Reference: Thames Water Section of the Datchet Common Brook

THE CURRENT BARREL ARCH DRAINAGE SYSTEM
SECTION SHOWING PRINCIPLE OF LEVELS THROUGH DITCHET PARISH.

SKETCH OF DITCHET
WATER COURSE SYSTEM

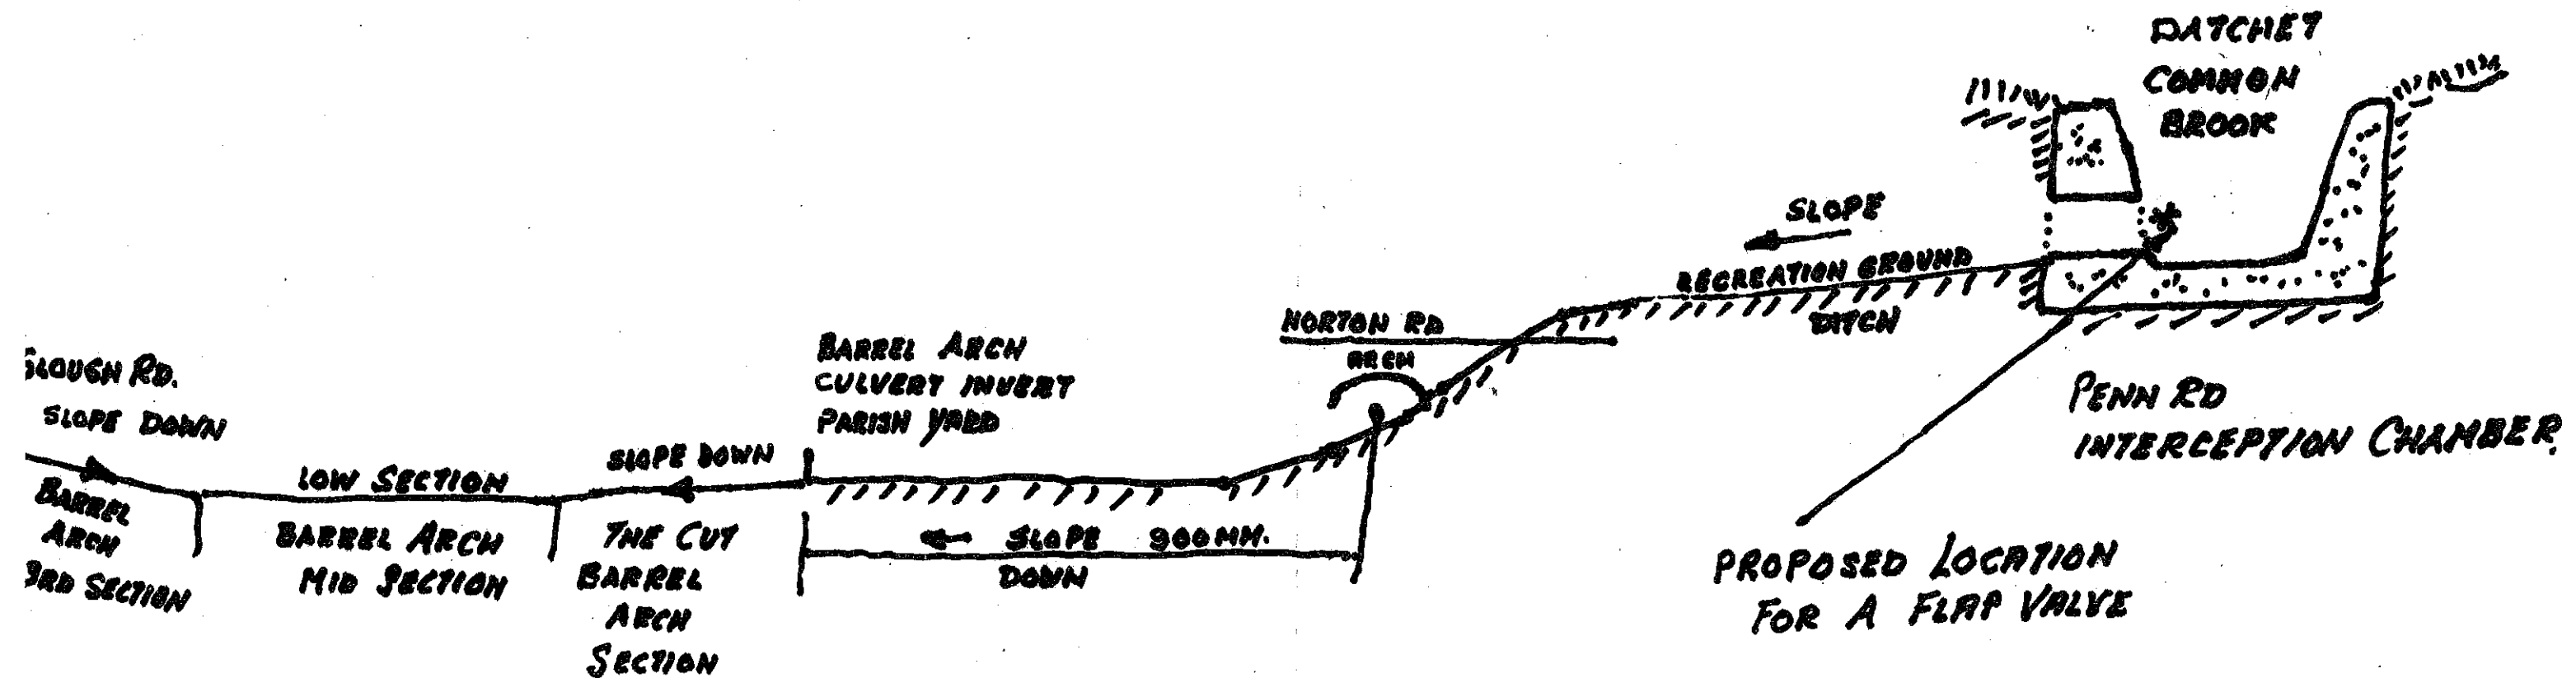
THE LOCATION OF THE REC DITCH BRANCH OF THE INTERCEPTION CHAMBER IS LOCATED ON A HIGHER GROUND LEVEL TO EITHER THE REC DITCH AND THE BARREL ARCH SYSTEM WITHIN CENTRAL DATCHET.

PREVENT UNWANTED WATER FROM ELSEWHERE CONTAINED WITHIN THE DATCHET COMMON BROOK ENTERING THE REC DITCH / BARREL ARCH SYSTEM.
